APPENDIX 15-4

Crumhach Wind Farm, Co. Sligo

Stage 1 Road Safety Audit

JOB NUMBER: 260039			DOCUMENT REF: 260039RPT001_RSA1_Rev_1			
1	Final Issue	MD	MD	MD	MD	6 Aug 2026
0	Draft Issue	SK	MD	SK	MD	24 Apr 2026
Revision	Purpose Description	Originated	Checked	Reviewed	Authorised	Date

Figure 2.2 – Location Where Passing Motorists Could Access the Redundant Access Track

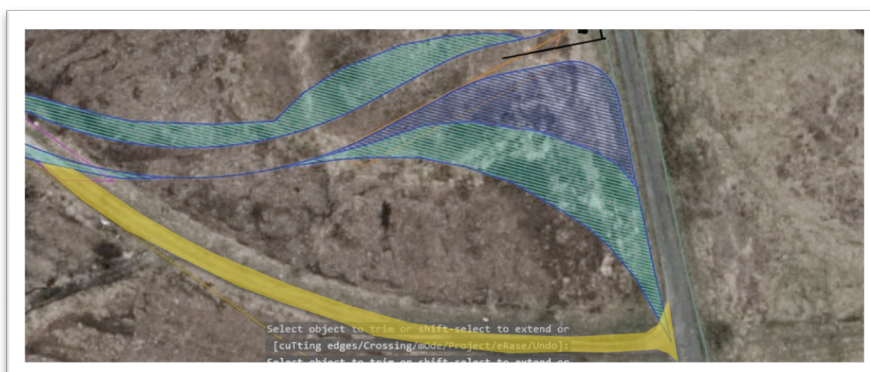
2.2 Problem: Drivers Confused by Redundant Access Track

Location: Site Access B – Local Road L2702, Existing Access Track to South

The existing section of access track (made redundant by Site Access B) might create confusion for drivers who could enter it by mistake, leading to sudden braking, loss of control or conflicts with construction traffic.

Recommendation

The section of redundant access track should be removed.

2.1	Access A For Record Purposes Only. No Safety Issues Identified.			
2.2	Yes	No	It is proposed that the existing access will be retained for local access only and managed during the construction phase. It is proposed that both accesses are gated with the opening of each access managed on site during the construction phase. On the completion of construction the over-run areas will be closed off permanently. Appropriate signage will be put in place at both the existing and proposed new access tracks to clearly distinguish the existing access for local landowners from construction and operational access to the Proposed Wind Farm.	Yes

Figure 2.3 – Location Where Passing Motorists Could Access the Overrun Area (When Not in Use)

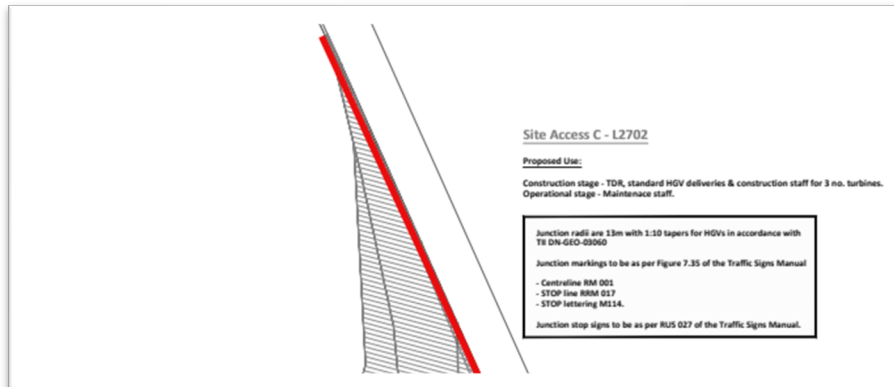
2.3 Problem: Passing Motorists Accessing Vehicle Overrun Area

Location: Site Access C – Local Road L2702

The temporary over-run area might create confusion for passing motorists, who could access it by mistake, leading to sudden braking, loss of control or conflicts with construction traffic.

Recommendation

The Designer should ensure that a suitable barrier is put in place to prevent passing motorists from accessing the abnormal load overrun area when it is not in use.

2.3	Yes	Yes	A suitable barrier will be put in place at all times during the construction stage and opened only on the nights that the abnormal loads are delivered. On these occasions the deliveries will be accompanied by a Garda escort and the opened junction will be attended by site staff. On the completion of construction the over-run areas will be closed off permanently.	Comment noted
